Exception Request No.: 82
Section: WBR3
Town: Woodstock
Highway: US 3 (Tier 2)
Station: 1665+30 to 1665+80±
Drawing No.: WBR3 C122
Survey Report Reference No.: WBR3 C118
Exception Type: Alignment in Pavement (Road Crossing)

EXCEPTION 82 - HIGHWAY CROSSING
 NPT WBR3-UNDERGROUND ALIGNMENT
 WBR3 SECTION - STA 1665+30 TO STA 1665+80±
 DATE: 05/2017

EXHIBIT A

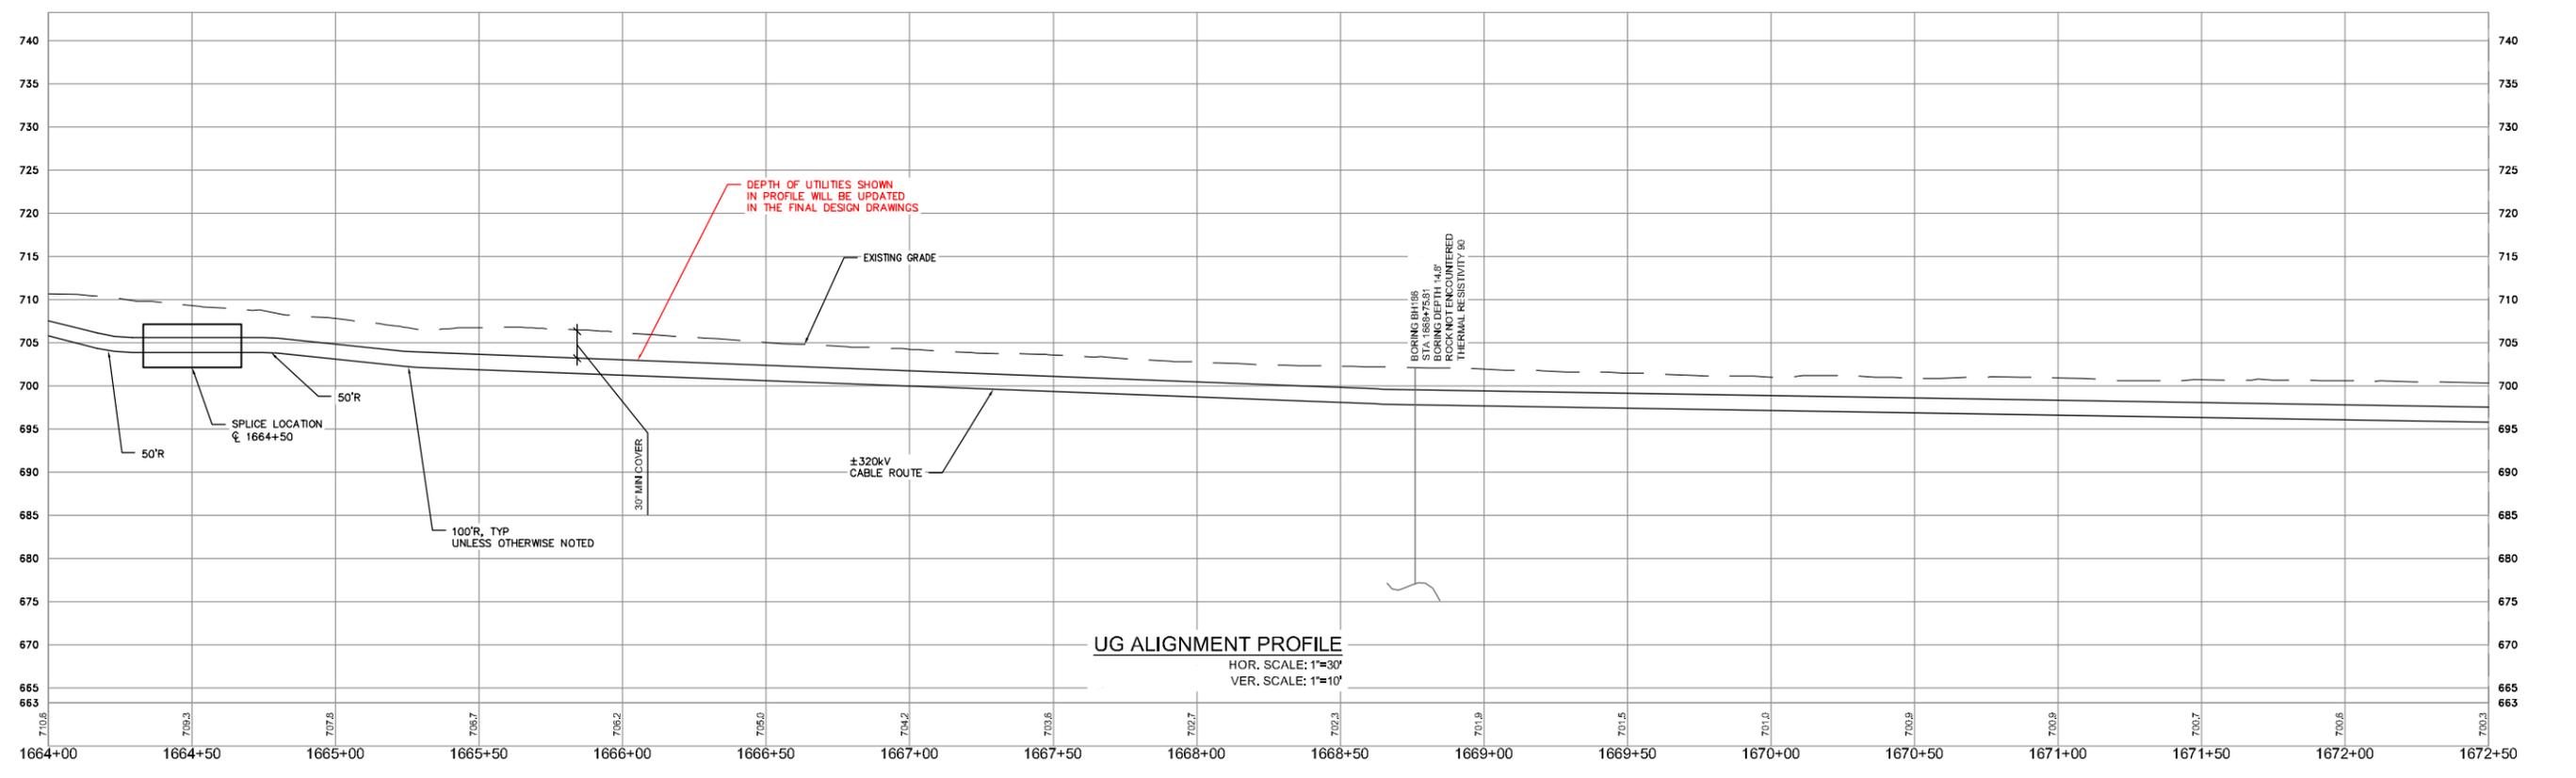
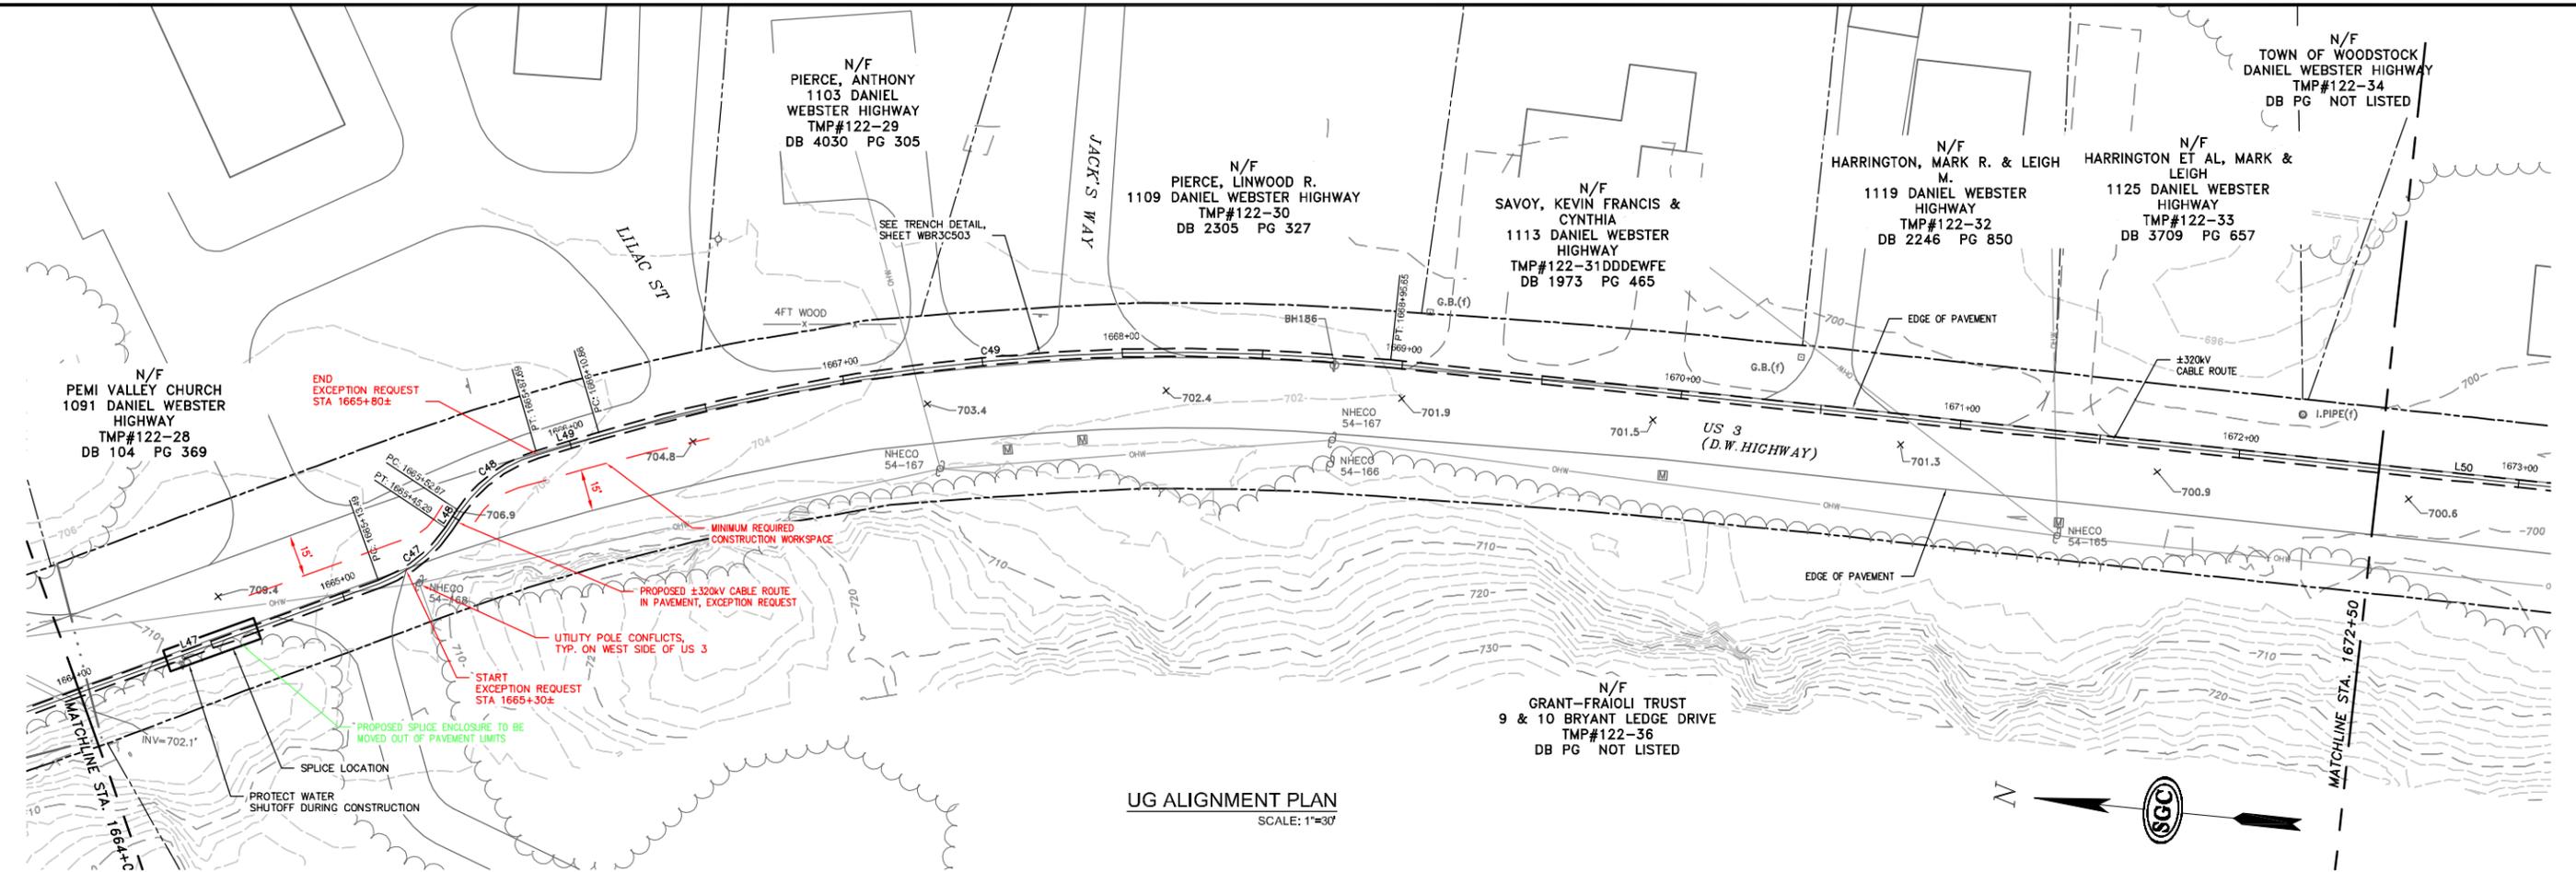
NPT is requesting an exception from the UAM guidelines for the location of the cable trench in the pavement on US 3, Daniel Webster Highway from station 1665+30 to 1665+80 of the NPT WBR3 Underground Alignment in order to cross from the west side of US 3 to the east side. (See Exhibit A.) Just south of the location of the proposed crossing, there is an overhead distribution line that would preclude placement of the ductbank off the roadway on the west side, because relocation of the distribution line is constrained by space, the need for additional real estate rights for relocation, and potential impacts to mature trees. Crossing to the east side will allow the ductbank to be installed off the paved roadway on the eastern side of the roadway.

NPT proposes to cross from the western to the eastern side of US 3 in the exception area because of constraints posed by utility poles associated with an overhead distribution line on the western side of US 3, just south of the proposed highway crossing. The existing overhead distribution line runs along the west side of the ROW. Relocating the utility poles closer to the edge of the ROW to provide sufficient area to construct the ductbank off the pavement on the west side will not provide a sufficient area between the edge of pavement, or will require additional rights for the installation of guys and anchors on private property outside the NHDOT ROW. In addition, moving the utility poles further away from the edge of pavement will create vegetation clearance issues to the overhead lines, requiring additional trimming and cutting of mature trees beyond the edge of the ROW.

The proposed crossing is consistent with NHDOT's goal to minimize the amount of the alignment in the paved roadway because it will shift the alignment to the east side where there is sufficient room to install the ductbank outside of the paved area.

Excavation limits and work areas are shown on the attached drawing (See Exhibit A). During construction, one lane will remain open to traffic at all times.
